**Supplemental Safety Evaluation**  
**For The**  
**General Electric Topical Report**  
**Qualification Of The One-Dimensional**  
**Core Transient Model For**  
**Boiling Water Reactors**  
**NEDO-24154 and NEDE-24154P**  
**Volumes I, II and III**

**Reactor Systems Branch, DSI**

**January 1981**

Figure 2-1. 5% Significance Coefficient (A) vs. Surveillance Data in Cycle

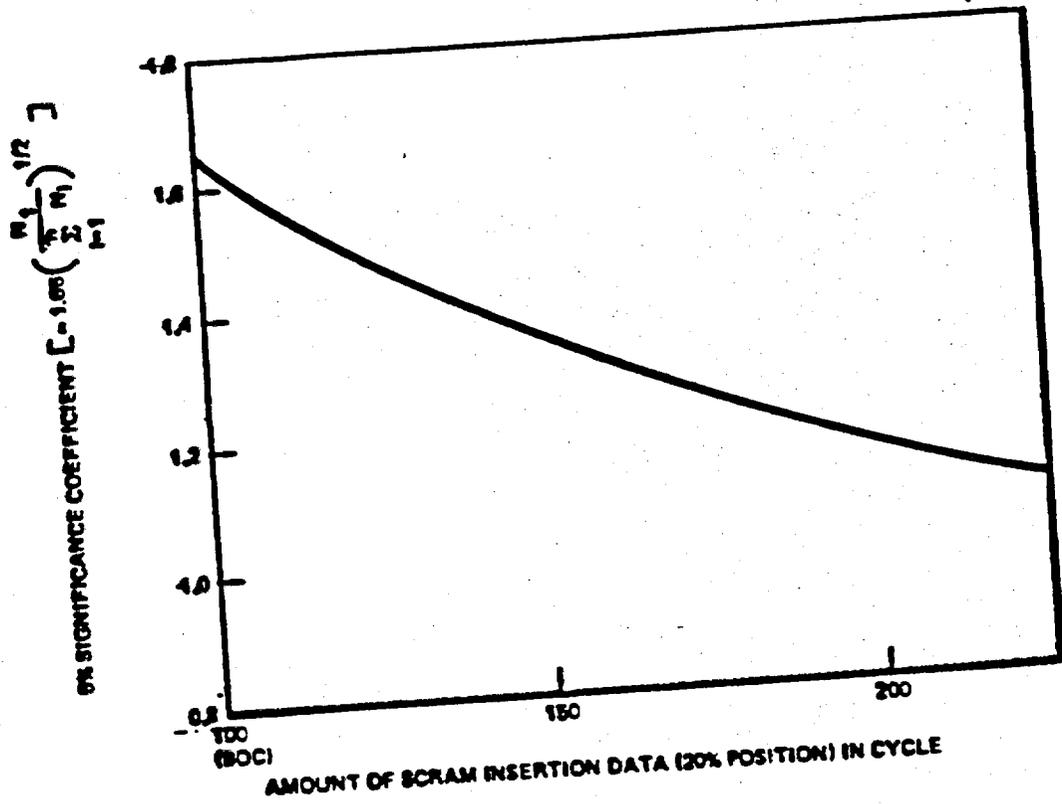
The relationship between the coefficient, A, and the amount of surveillance data generated during the cycle is illustrated in Figure 2-1. As more data become available through the performance of in-cycle surveillance tests, the coefficient decreases, as does the acceptance criterion,  $\tau_B$ . Thus, the scram speed criterion is being tightened as the cycle progresses, based on the assumption that, as more scram data become available during the cycle, the uncertainty in the mean value calculation should decrease.

We find the scram insertion time conformance procedure to be acceptable.
